UNITED STATES PATENT AND TRADEMARK OFFICE

APPLICATION NO.	FILING DATE	FIRST NAMED INVENTOR	ATTORNEY DOCKET NO.	CONFIRMATION NO.
09/918,886	07/30/2001	Ting K. Yee	20852-05682	3294
35690	7590	02/27/2006	EXAMINER	
MEYERTONS, HOOD, KIVLIN, KOWERT & GOETZEL, P.C.			KIM, DAVID S	
P.O. BOX 398			ART UNIT	
AUSTIN, TX 78767-0398			PAPER NUMBER	
			2633	
DATE MAILED: 02/27/2006

Office Action Summary	Application No. 09/918,886	Applicant(s) YEE ET AL	
	Examiner David S. Kim	Art Unit 2633

DETAILED ACTION

FIG. 1

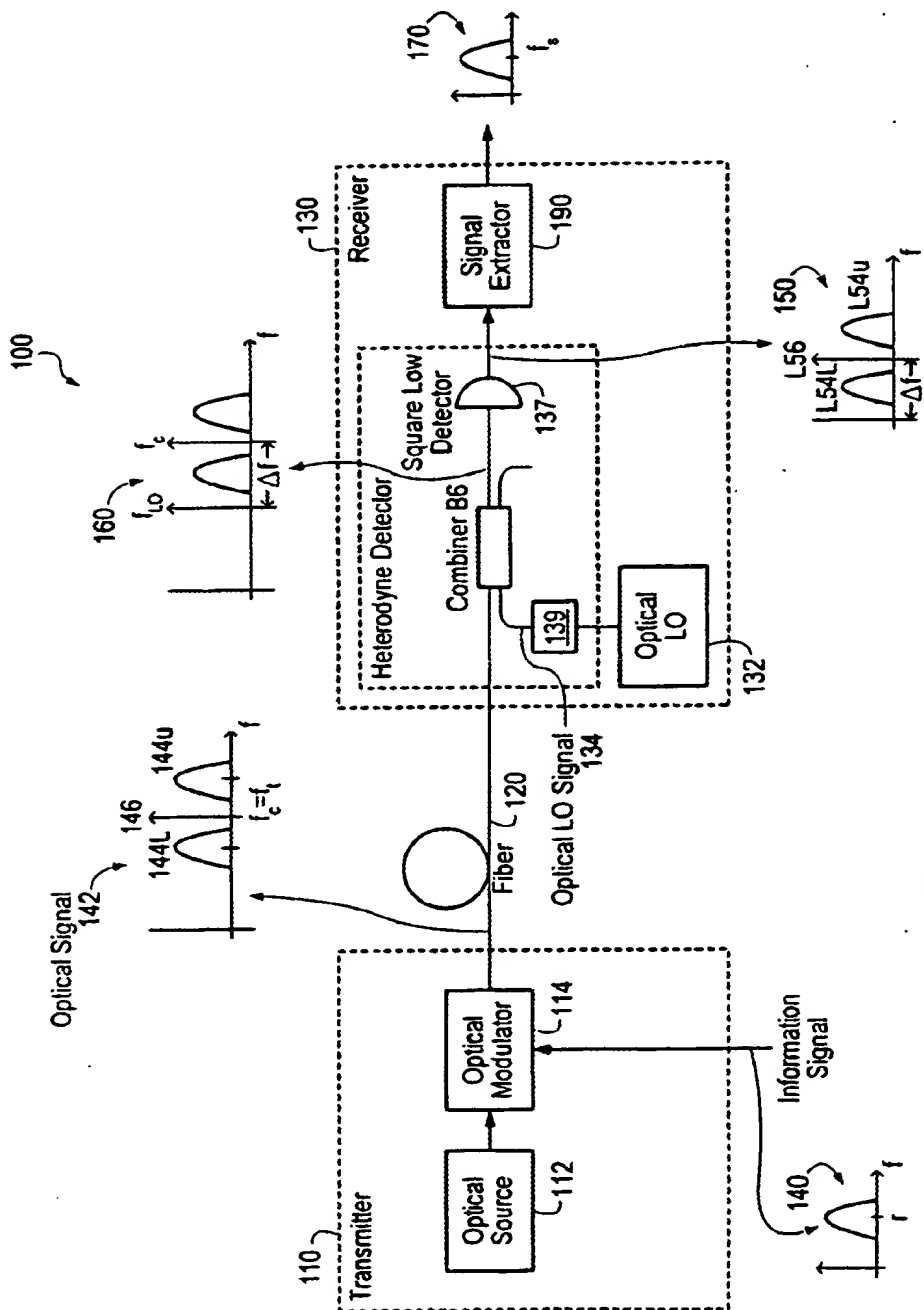
In Fig. 1, replace the frequency label "r" with "f_r" under the spectrum 140. See paragraph [0056] for support.

In Fig. 1, label the heterodyne detector with "180" as in the old Fig. 1 filed on 30 July 2001. See paragraph [0055] for support.

In Fig. 1, replace reference characters "L54L", "L54u", and "L56" with "154L", "154u", and "156", respectively, as in old Fig. 1 filed on 30 July 2001. See paragraph [0059] for support.

In Fig. 1, delete " f_s " under the reference character "170". Paragraph [0059] teaches that component 170 may be offset from f_s instead of being located at f_s as shown in Fig. 1.

In Fig. 1, replace "B6" with "136" and replace "Low" with "Law". See paragraph [0062] for support.

FIG. 2

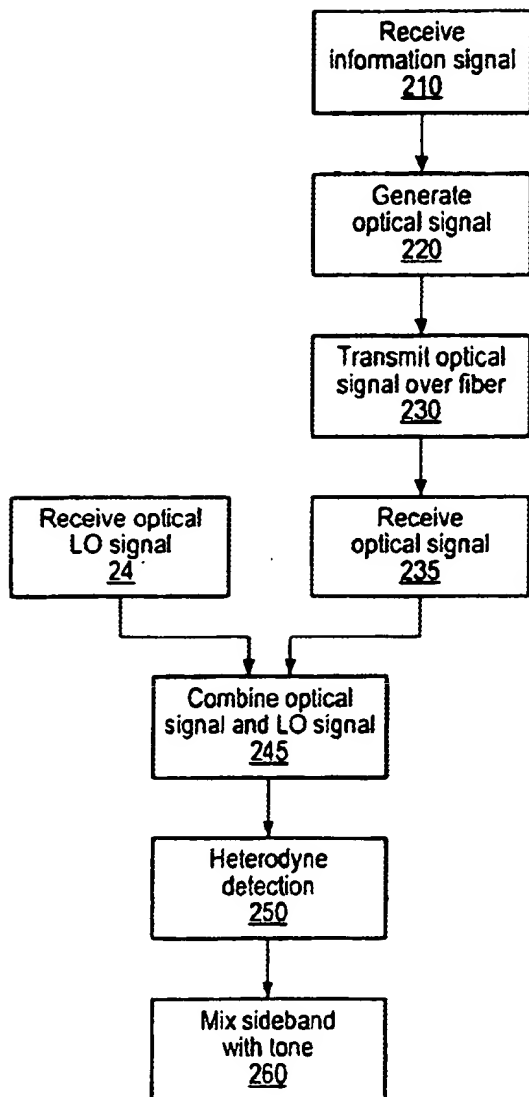
In Fig. 2, add a reference character "200" that points to the entire method. See paragraph [0028] for support.

In Fig. 2, replace reference character "24" with "240" as in old Fig. 2 filed on 30 July 2001. See paragraph [0059] for support.

FIG. 4

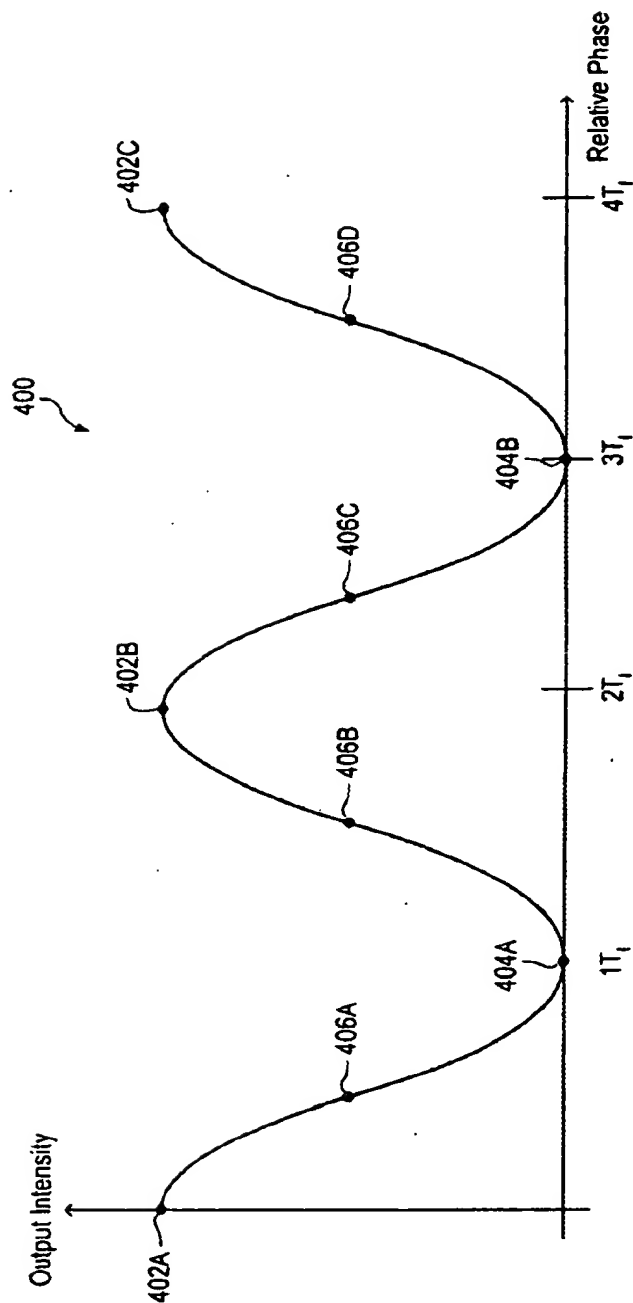
In Fig. 4, replace all instances of " T_i " with " π " as shown in old Fig. 4 filed on 30 July 2001. See paragraph [0067] for support.

FIG. 5

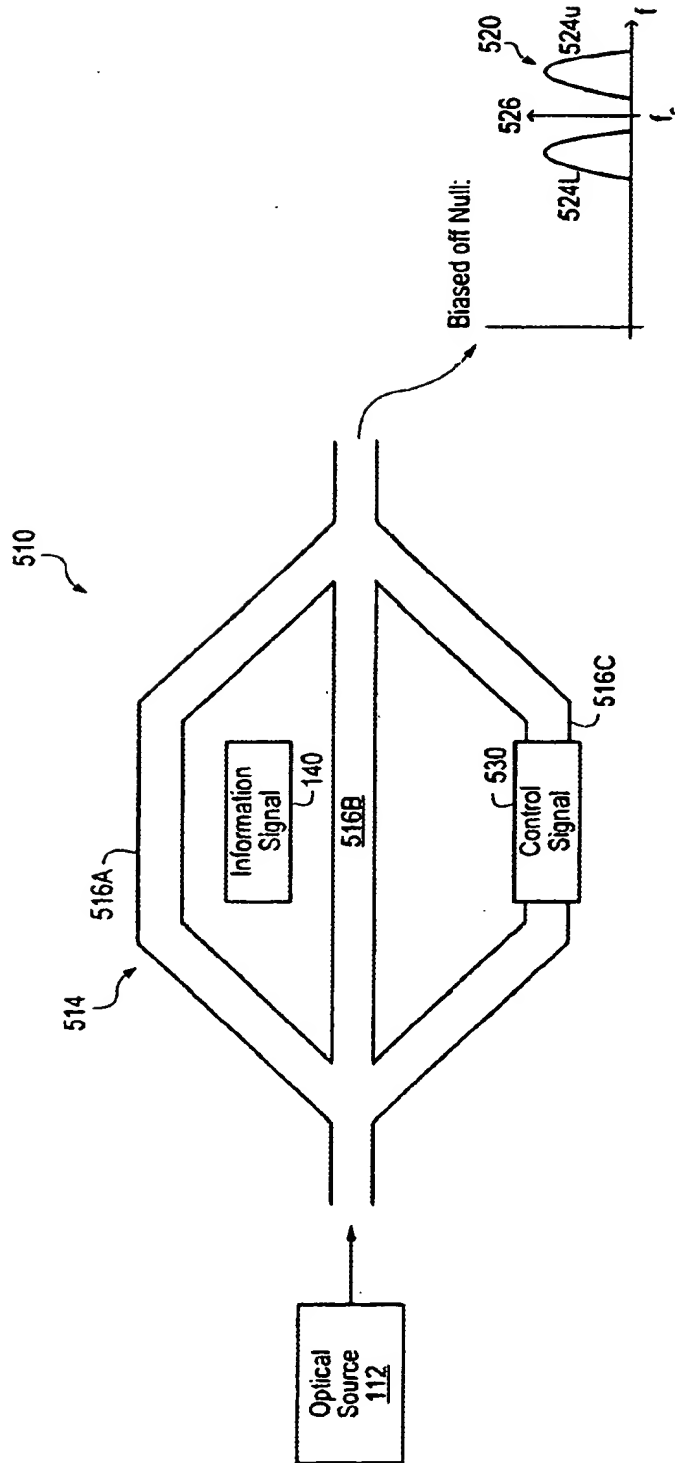
In Fig. 5, replace "Biased off Null" with "Biased at Null" as shown in old Fig. 5 filed on 30 July 2001.

FIG. 7

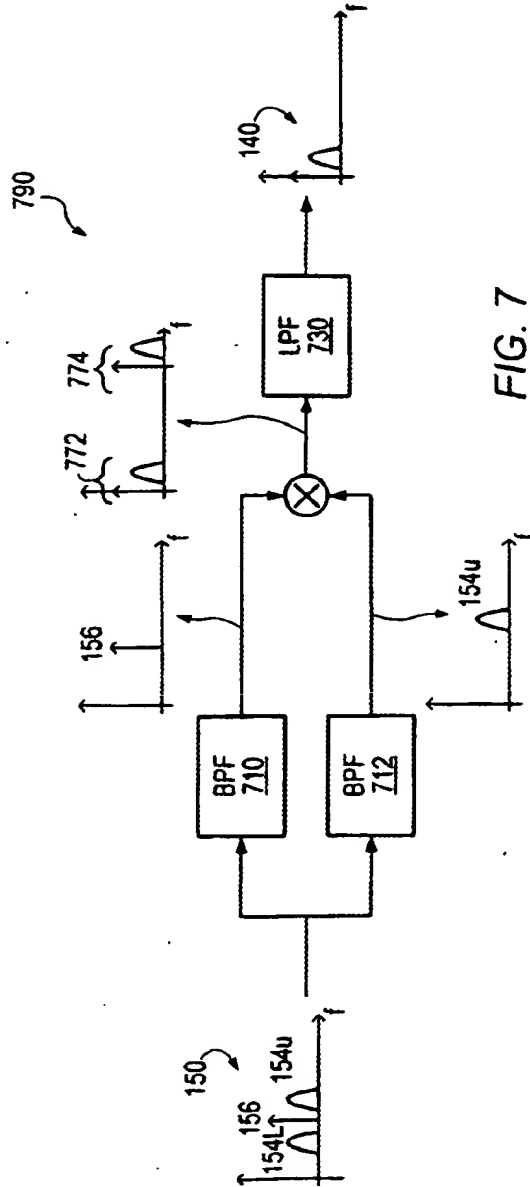
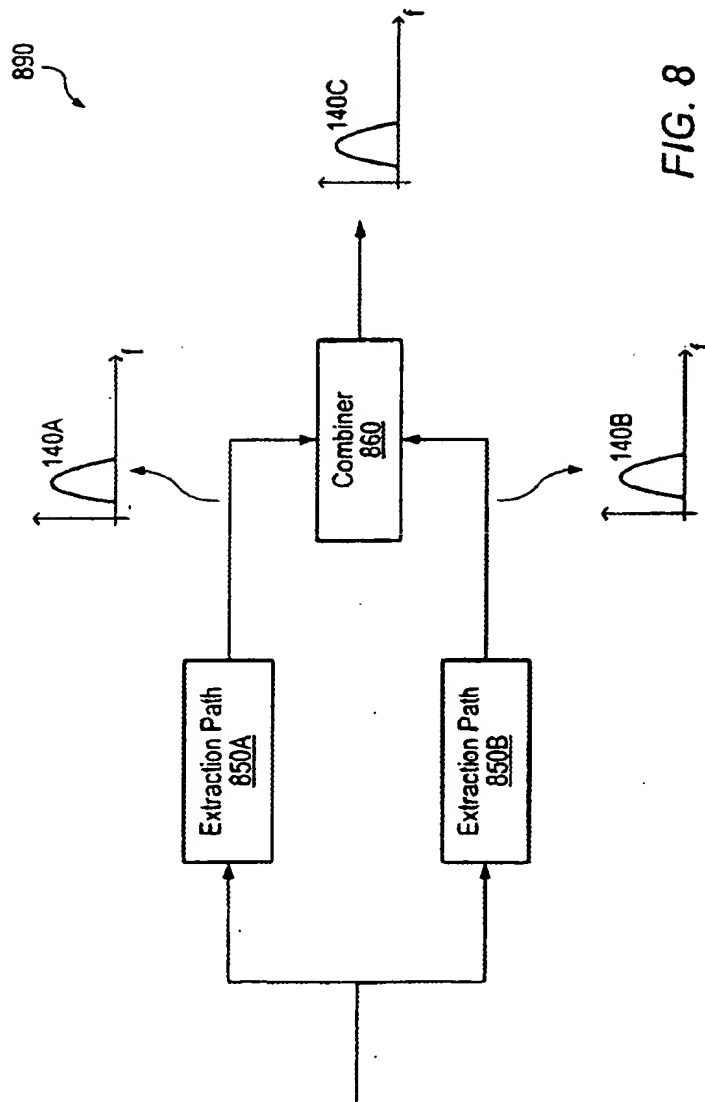
In Fig. 7, add a reference character "720" that points to the multiplier as shown in old Fig. 7 filed on 30 July 2001. See paragraph [0074] for support.

FIG. 9

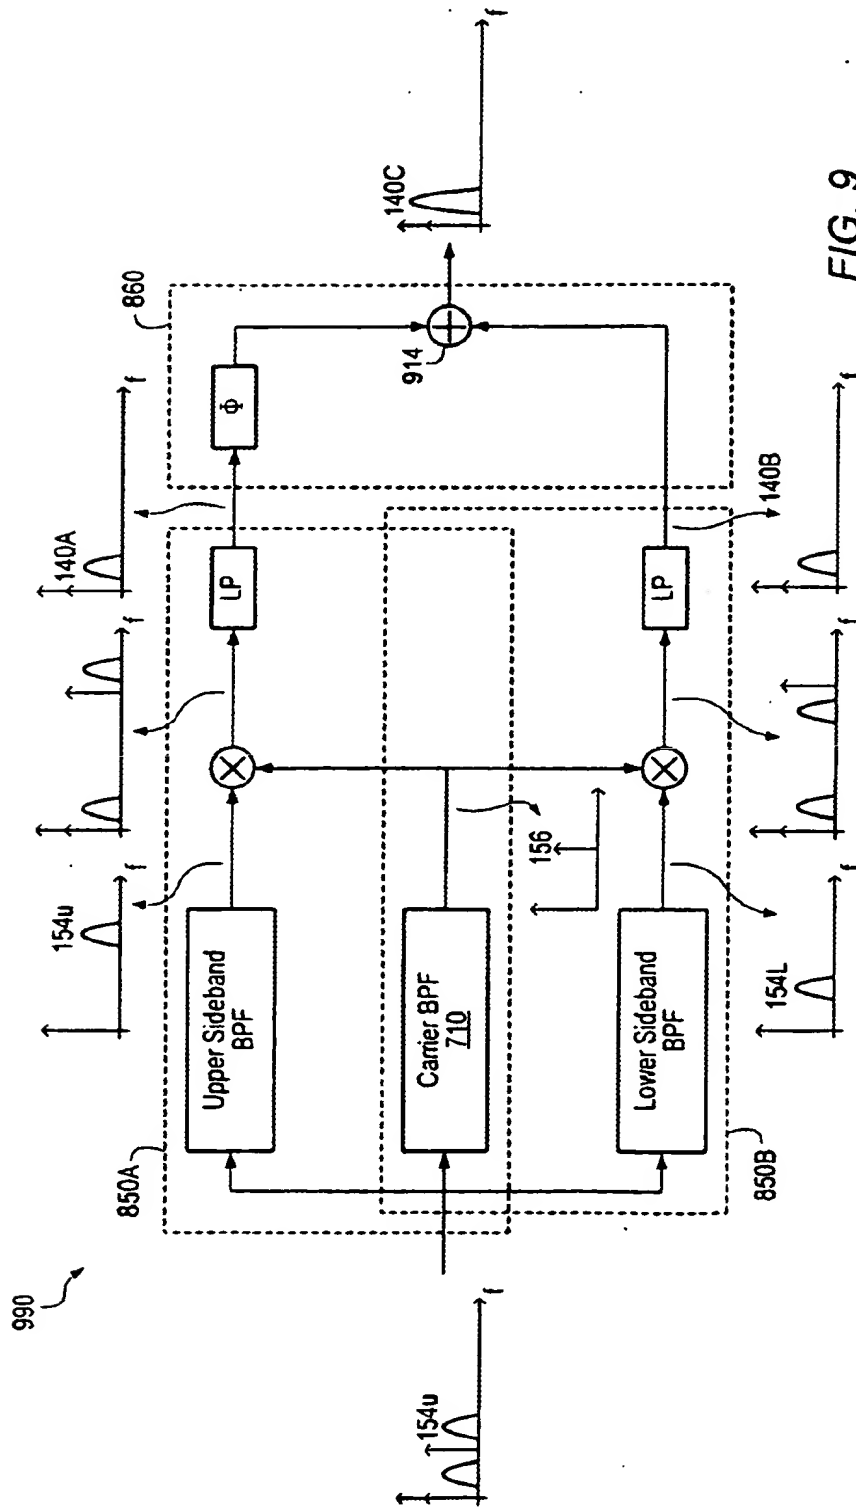
In Fig. 9, the input signal is missing labels "154L" and "156". See how Figs. 6-7 provide these labels.

In Fig. 9, add a reference character "720" that points to the upper multiplier. Also, add a reference character "720" that points to the lower multiplier. See paragraph [0079] for support.

In Fig. 9, add a reference character "912" that points to the phase shifting element as shown in old Fig. 9 filed on 30 July 2001. See paragraph [0080] for support.

FIG. 10

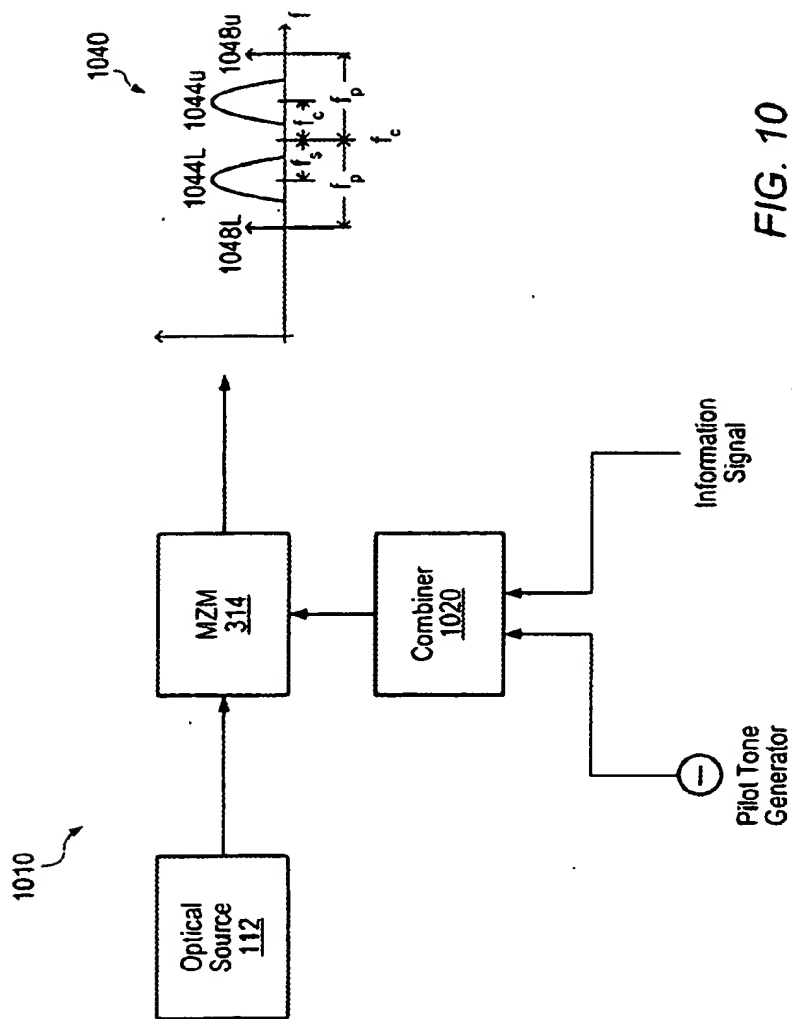
In Fig. 10, label the Pilot Tone Generator with "1030" as in old Fig. 10 filed on 30 July 2001. Also, label the Information Signal with "140" as in old Fig. 10 filed on 30 July 2001. See paragraph [0081] for support.

In Fig. 10, the spectrum drawing shows a label " f_c " next to a label " f_c ". Replace " f_c " with another instance of " f_c " so there are two instances of " f_c " next to each other as shown in old Fig. 10 filed on 30 July 2001.

FIG. 12

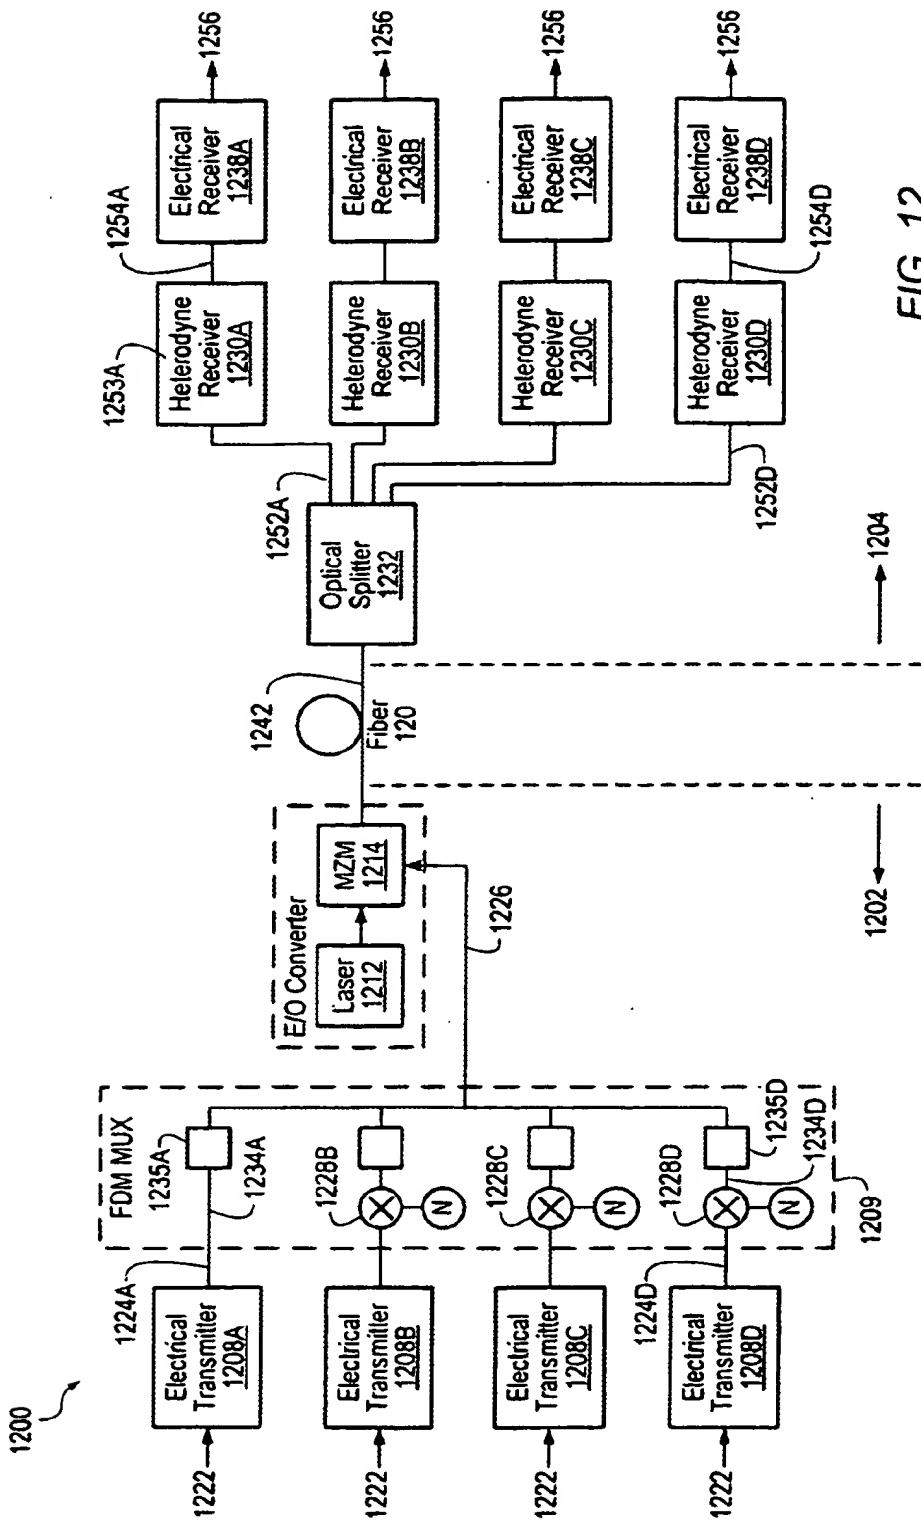
In Fig. 12, label the E/O Converter with "1210" as in old Fig. 12 filed on 30 July 2001. See paragraph [0092] for support.

FIG. 13A

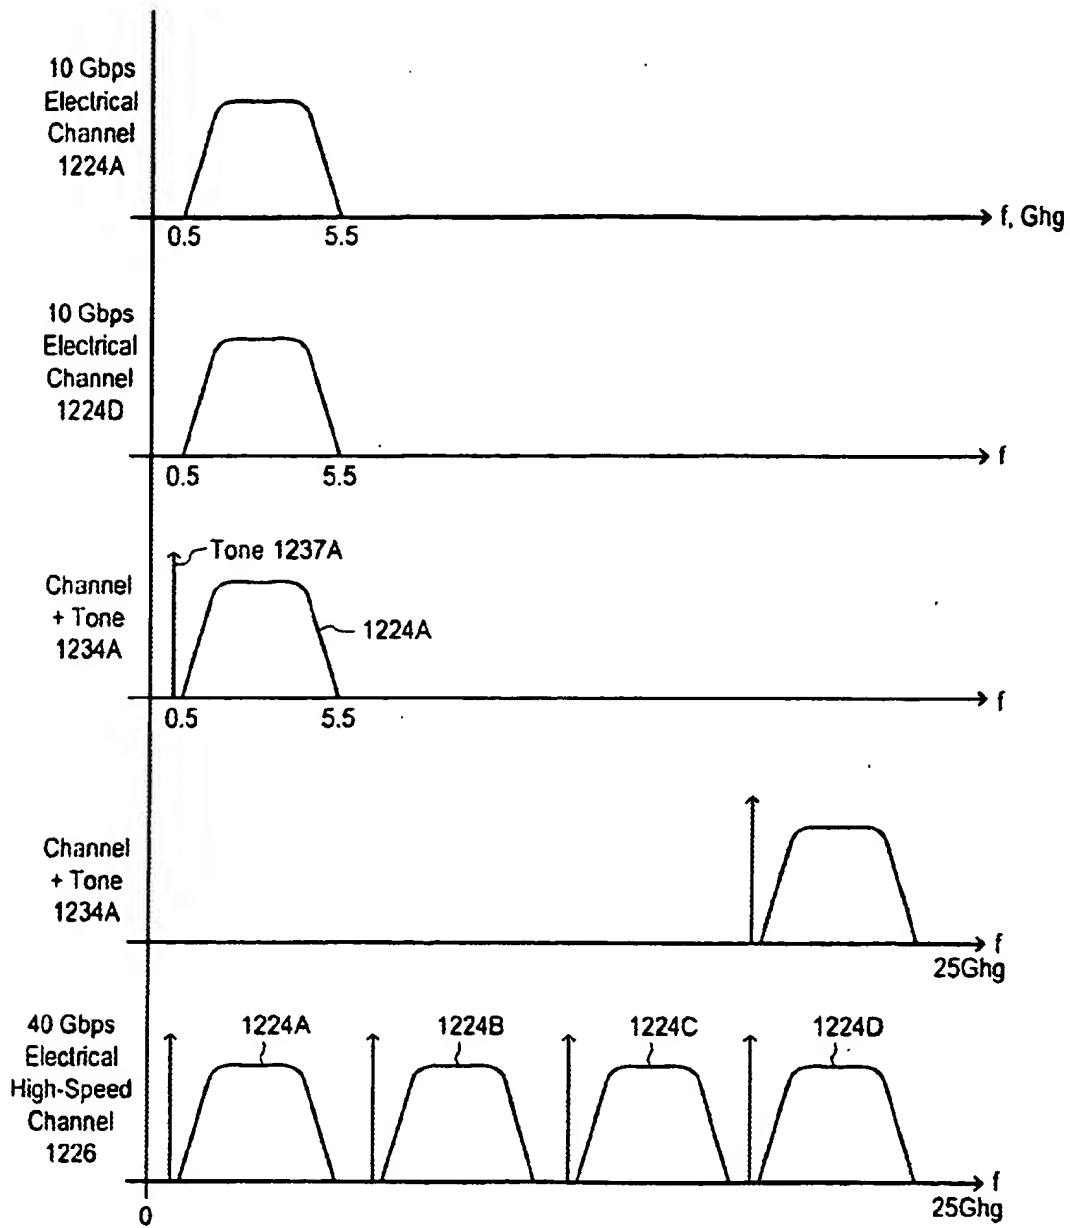
In Fig. 13A, there are two instances of "1234A". Replace the lower instance with "1234D" as in old Fig. 13A filed on 30 July 2001. See paragraph [0093] for support.

FIG. 13E

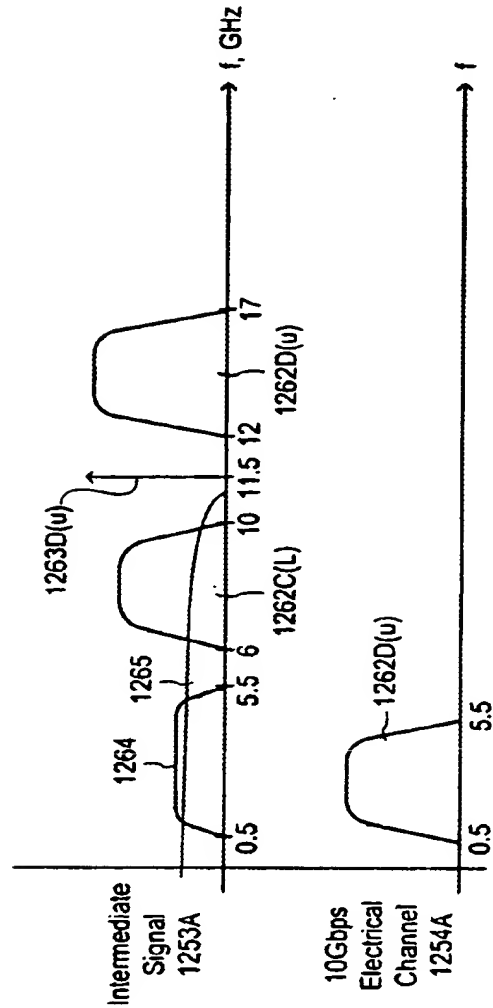
In Fig. 13E, replace "1253A" with "1253D" and replace "1254A" with "1254D" and replace "1262C(L)" with "1262C(U)" as shown in old Fig. 13E filed on 30 July 2001. See paragraph [0103] for support.
